Notification of Product/Process Change

Title of change	Change of wafer manufacturing site from ROHM HQ Plant to Shiga Plant (Small Signal Transistors)	
Affected product(s)	Manufacturer part number	Customer part number
	Refer attached sheet	
Detailed description of change	Before	After
	Front-end fabrication plant; Kyoto	Front-end fabrication plant; Shiga
Reason for change	As part of the consolidation of production lines, the front-end operations will be centralized at the Shiga plant.	
Anticipated impact on quality	This change will not have any impact on quality.	
Identification of change	It can be identified through traceability from the assembly lot number.	
Planned first ship date : April 1, 2027		Sample available schedule : March 1, 2026
Comments	If you need existing products, please place your orders for the required quantities by March 31, 2027. Following the consolidated production, we would appreciate your cooperation in receiving the products in a single shipment.

Doc. No.3026001
Change of wafer manufacturing site from ROHM HQ Plant to Shiga Plant (Small Signal Transistors)

3026001-2. Manufacturing Flow Comparison

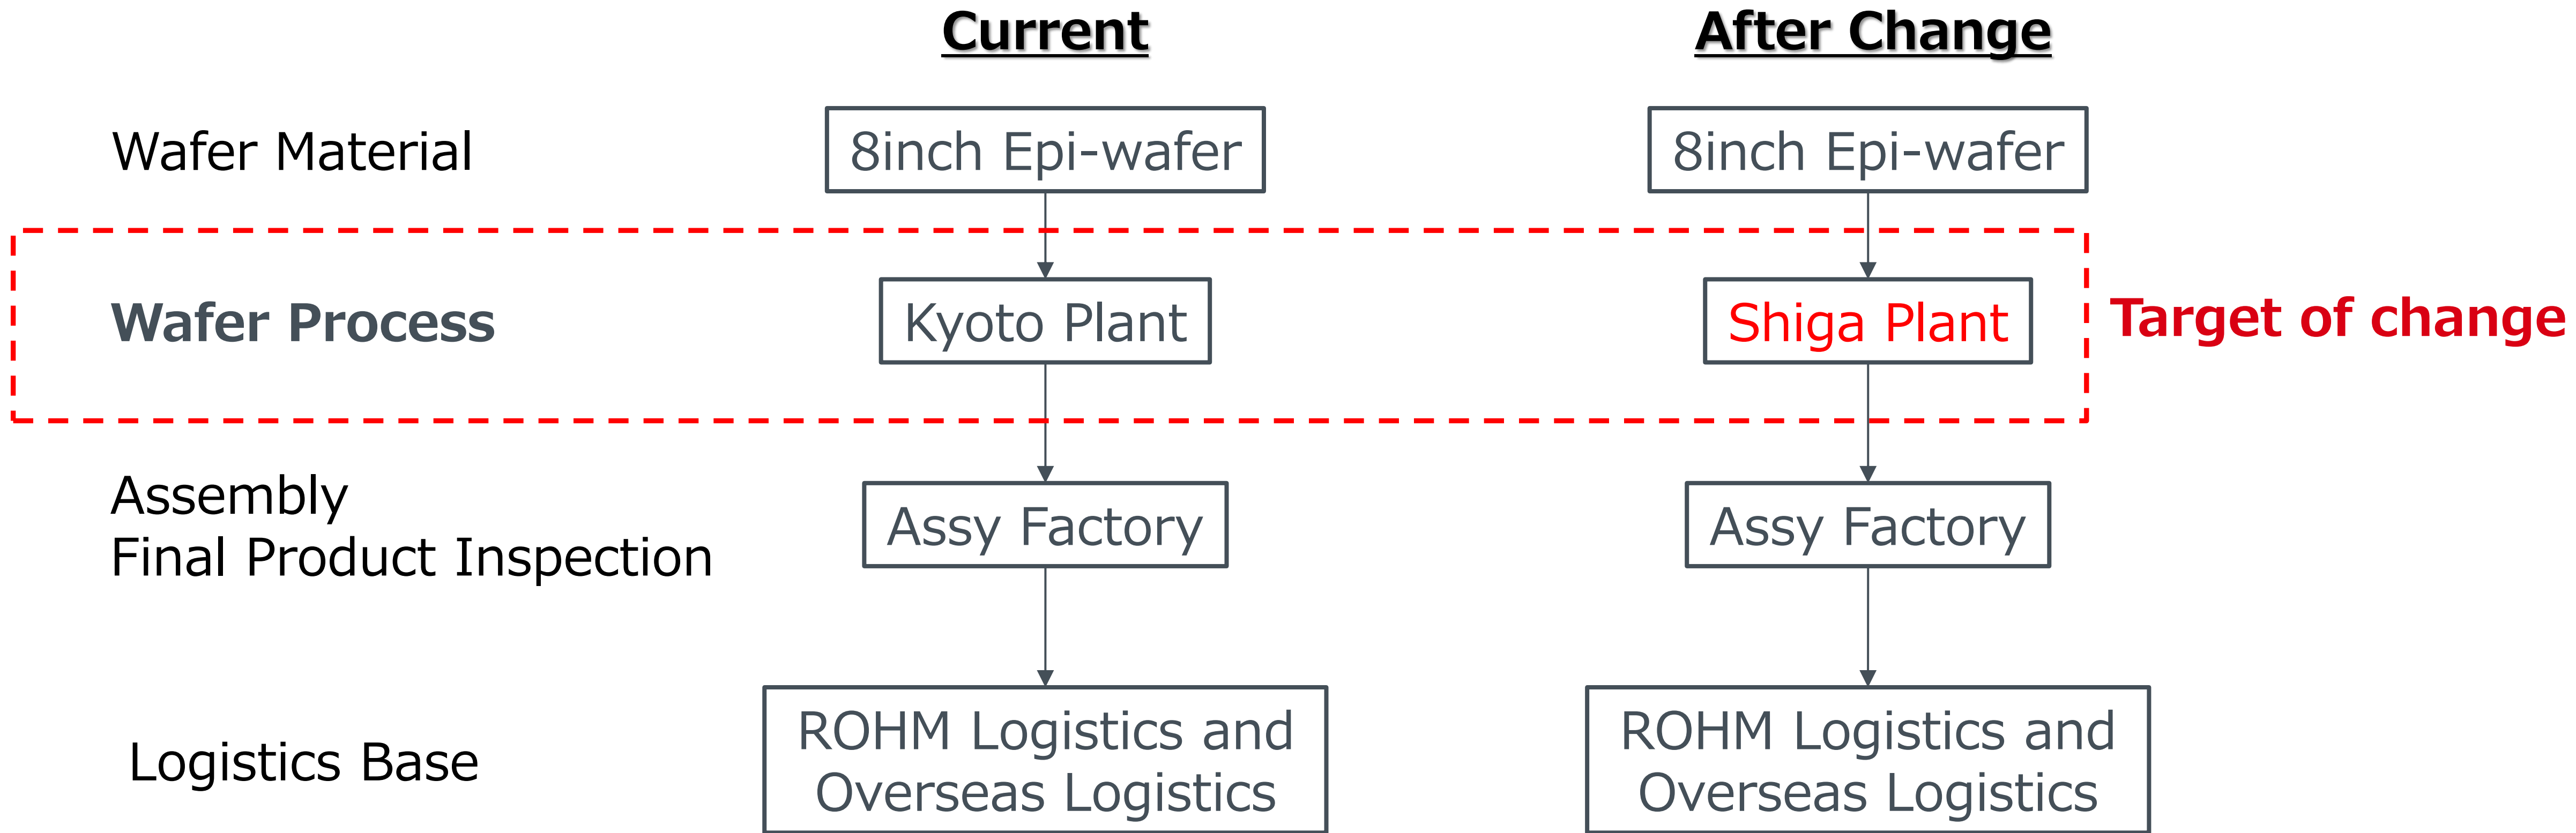
The front-end process (wafer Process) will be transferred from the Kyoto Plant to the Shiga Plant. There are no changes to wafer materials or processes after the back-end process (package assembly process).
